SUBJECT: ISSUANCE OF AMENDMENT (TAC NO. M83180)

NORTHEAST NUCLEAR ENERGY COMPANY
THE CONNECTICUT LIGHT AND POWER COMPANY
THE WESTERN MASSACHUSETTS ELECTRIC COMPANY
DOCKET NO. 50-336
MILLSTONE NUCLEAR POWER STATION, UNIT NO. 2
AMENDMENT TO FACILITY OPERATING LICENSE

Amendment No. 158
License No. DPR-65

SAFETY EVALUATION BY THE OFFICE OF NUCLEAR REACTOR REGULATION

FIGURE J.9-1 MINIMUM REQUIRED FUEL ASSEMBLY EXPOSURE AS A FUNCTION OF INITIAL ENRICHMENT TO PERMIT STORAGE IN REGION C

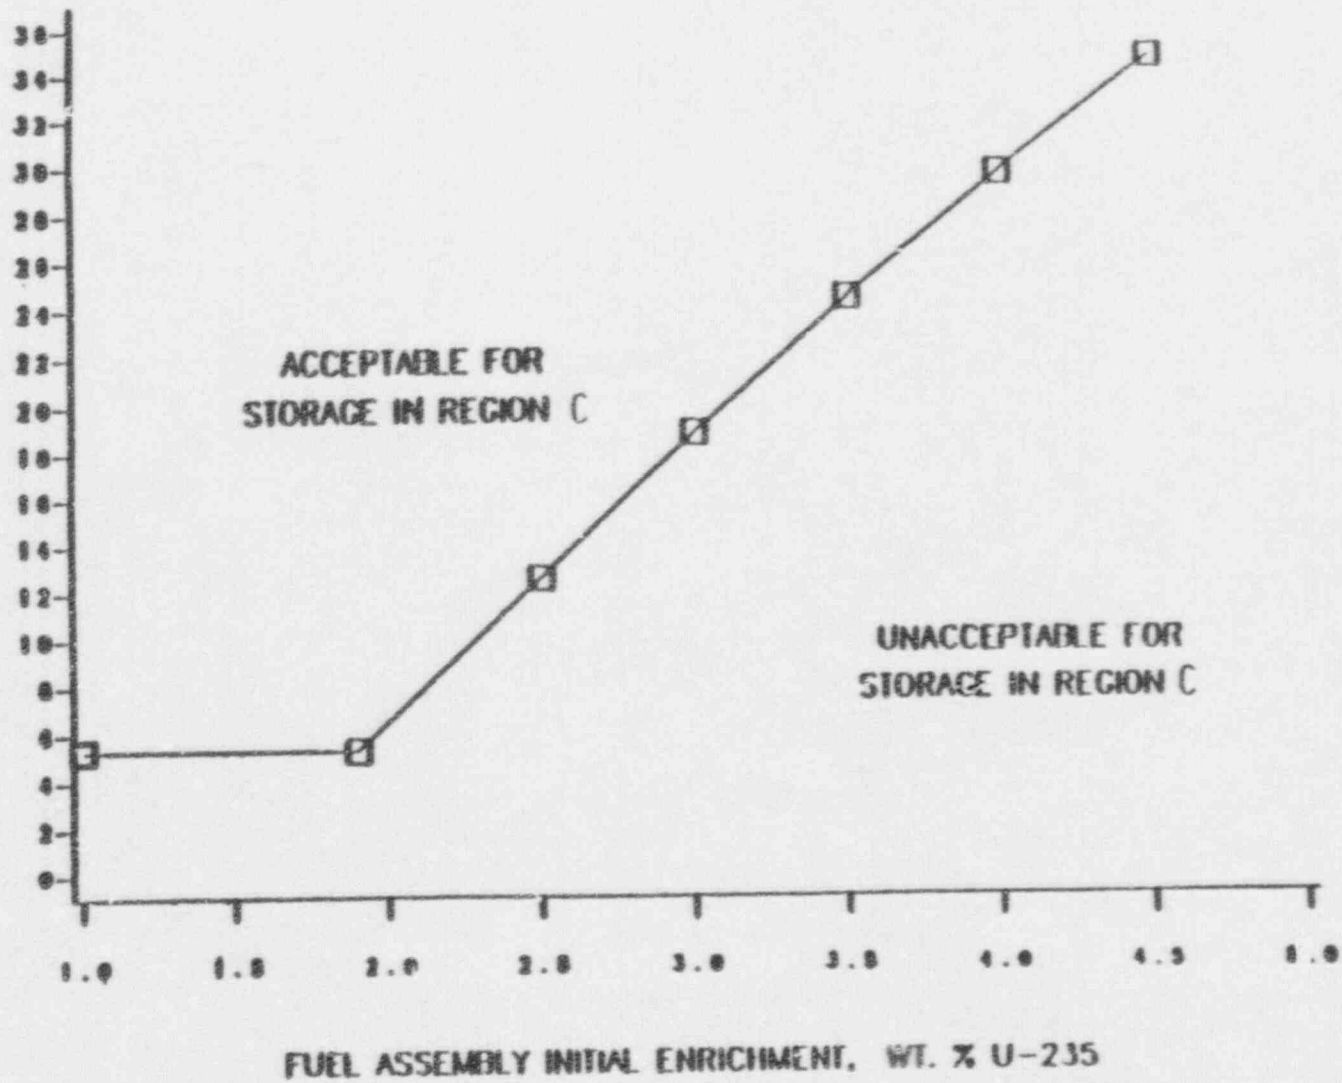
- (1) Definition 1.39, STORAGE PATTERN is currently defined for Region II. This is being changed to define the three-out-of-four array to be used in Regions B and C.
- (2) TS 3.9.17 is currently concerned with fuel movement over Region II racks (due to the dropped assembly accident and misplaced fuel assembly event). This is being changed from any fuel movement over the Region II racks to any fuel movement in the spent fuel pool.
- (3) TS 3.9.18 is being modified to change the wording in the surveillance requirements from Region II to Region C, and adds a surveillance requirement to ensure that fuel assemblies to be placed in Region A are within the enrichment and burnup limits of a new Figure 3.9-4.
- (4) Figure 3.9-1 is being modified to change the references from Region II to Region C.

4.9.18.1 Ensure that all fuel assemblies to be placed in Region C (as shown in Figure 3.9-2) of the spent fuel pool are within the enrichment and burn-up limits of Figure 3.9.1 by checking the assembly's design and burn-up documentation.

SPENT FUEL POOL ARRANGEMENT UNIT #2

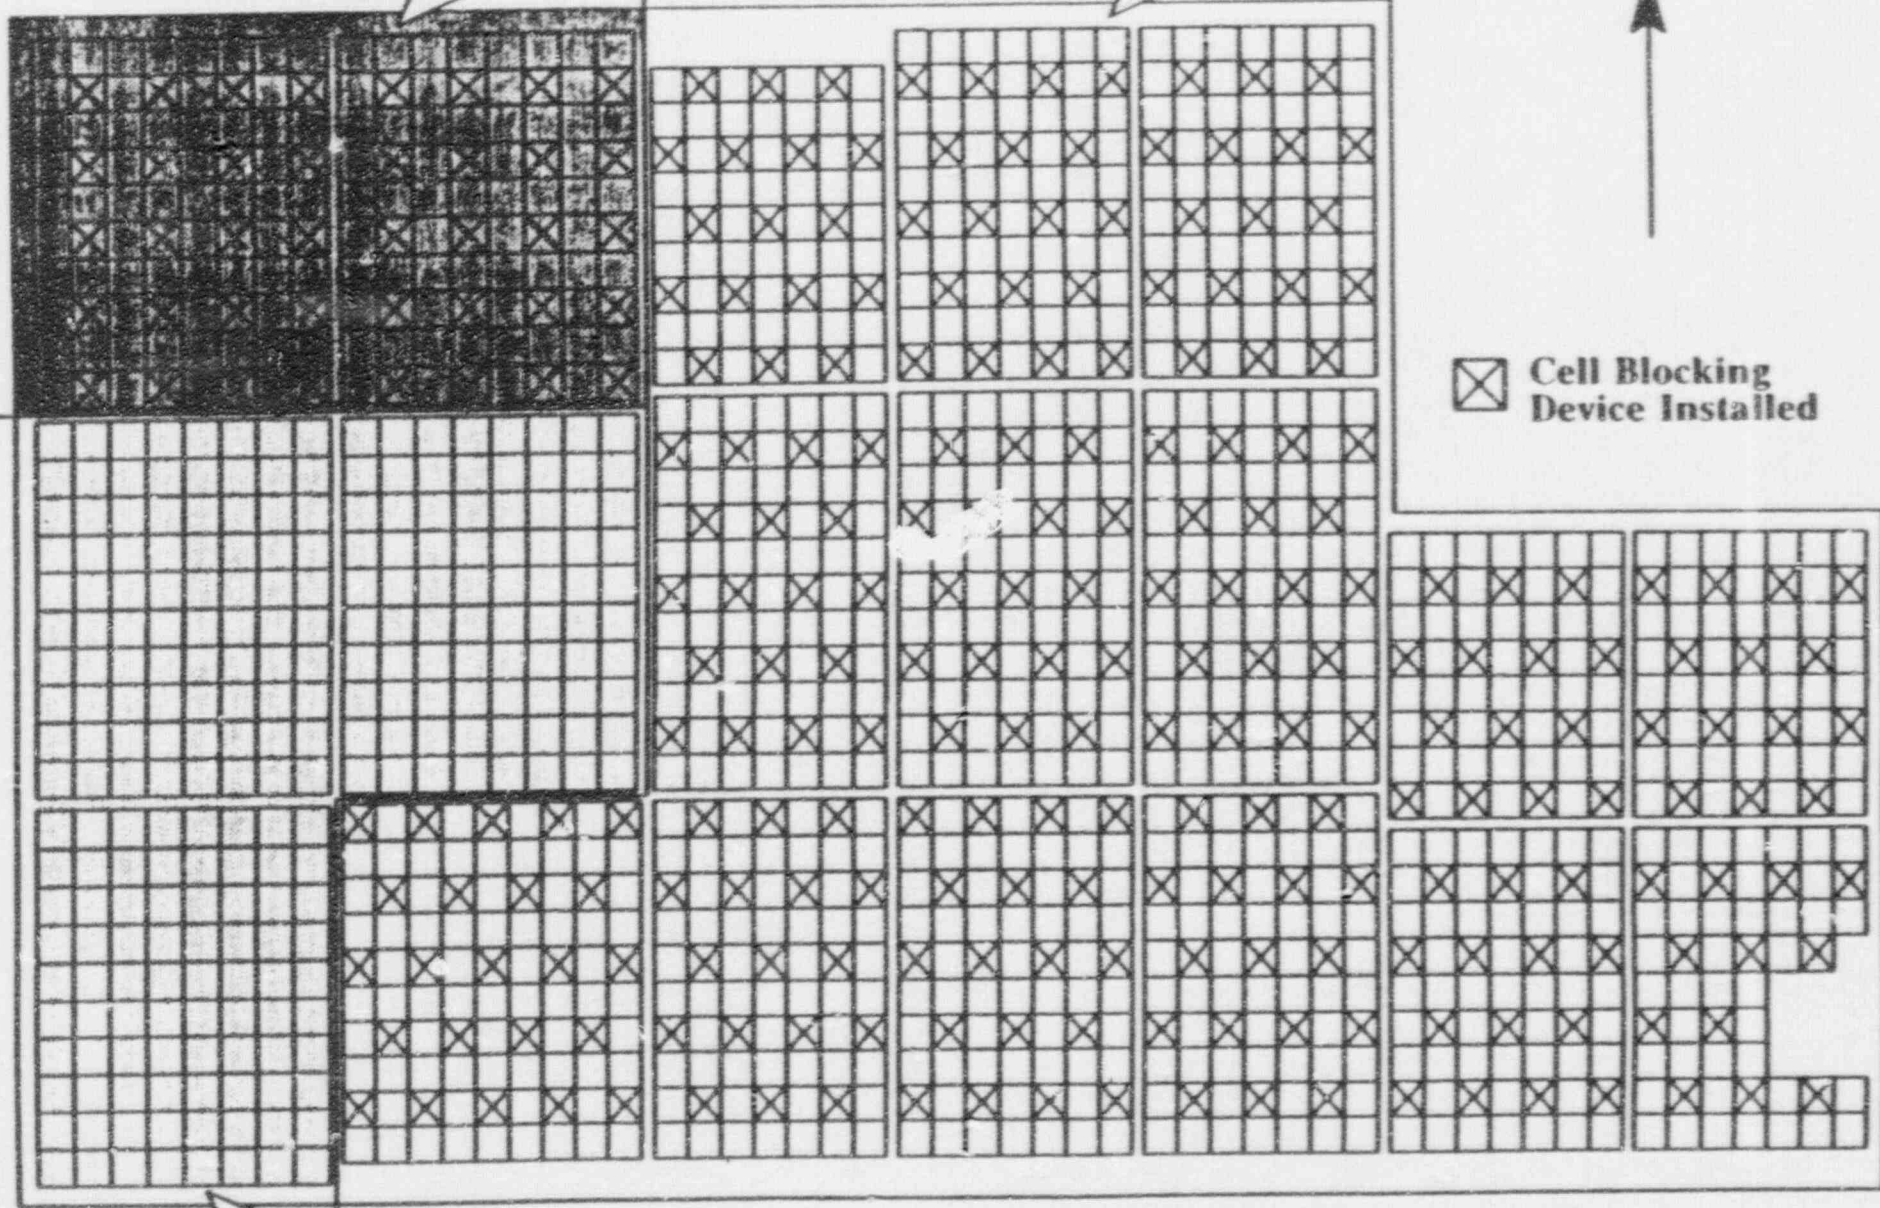
- (5) Figure 3.9-2 is being modified to delete the references from Regions I and II and add Regions A, B, and C.
- (6) Figure 3.9-3 is being modified to change the references from Region II to Region C.

- (1) A cell blocking device is installed in those cell locations shown in Figure 3.9-2; or
- (2) If a cell blocking device has been removed, all cells of the STORAGE PATTERN must have consolidated fuel in them, including the formerly blocked location; or
- (3) Meet both (a) and (b):
 - (a) If a cell blocking device has been removed, all cells of the STORAGE PATTERN must have consolidated fuel in them except the formerly blocked location.
 - (b) The formerly blocked location is vacant and a consolidated fuel box or cell blocking device is immediately being placed into the formerly blocked cell.

- (1) A cell blocking device is installed in those cell locations shown in Figure 3.9-2; or
- (2) If a cell blocking device has been removed, all cells in the STORAGE PATTERN must be vacant of stored fuel assemblies.

FIG. 3.3-4 MINIMUM REQUIRED FUEL ASSEMBLY EXPOSURE AS A FUNCTION OF INITIAL ENRICHMENT TO PERMIT STORAGE IN REGION A

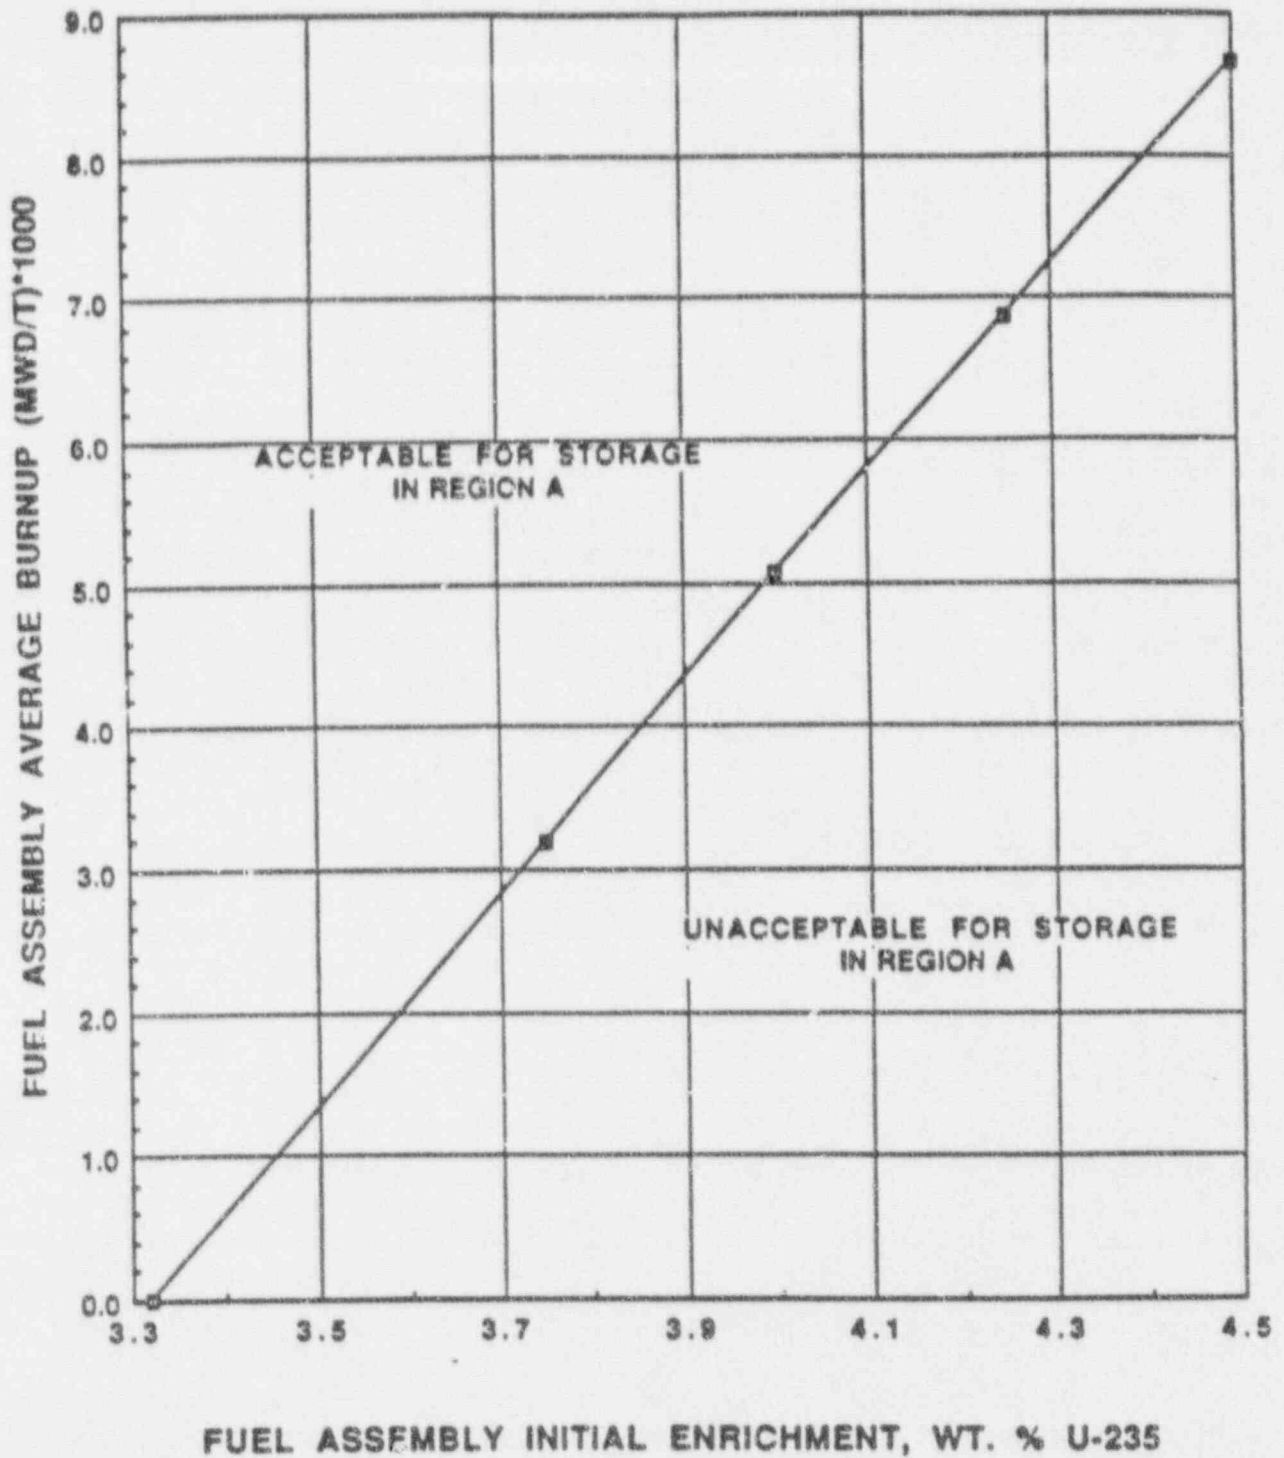
The old Region I rack design was also reanalyzed utilizing all of the cells in a four-out-of-four cell arrangement with credit for fuel burnup (new Region A designation). The same Boraflex gap distribution assumed in the Region B analysis was used. As seen from TS Figure 3.9-4, fuel with an initial enrichment of 4.5 w/o U-235 and minimum burnup of 8670 MWD/MTU is equivalent to unirradiated fuel enriched to 3.3 w/o U-235. The resulting maximum (95/95) k-eff was 0.9317 for ANF fuel, 0.9381 for Westinghouse fuel, and 0.9335 for CE fuel, all within the 0.95 limiting criterion.

- (7) A new Figure 3.9-4 is being added to specify the allowable enrichment and burnup limits for fuel assemblies to be stored in Region A.
- (8) TS 3.9.19 is being split into two parts:

4.9.18.3 Ensure that all fuel assemblies to be placed in Region A (as shown in Figure 3.9-2) of the spent fuel pool are within the enrichment and burnup limits of Figure 3.9-4 by checking the assembly's design and burnup documentation.

b) Region A of the spent fuel storage pool is designed and shall be maintained with a nominal 9.8 inch center to center distance between storage locations to ensure a $K_{eff} \leq .95$ with the storage pool filled with unborated water. Fuel assemblies stored in this region must comply with Figure 3.9-4 to ensure that the design burnup has been sustained.
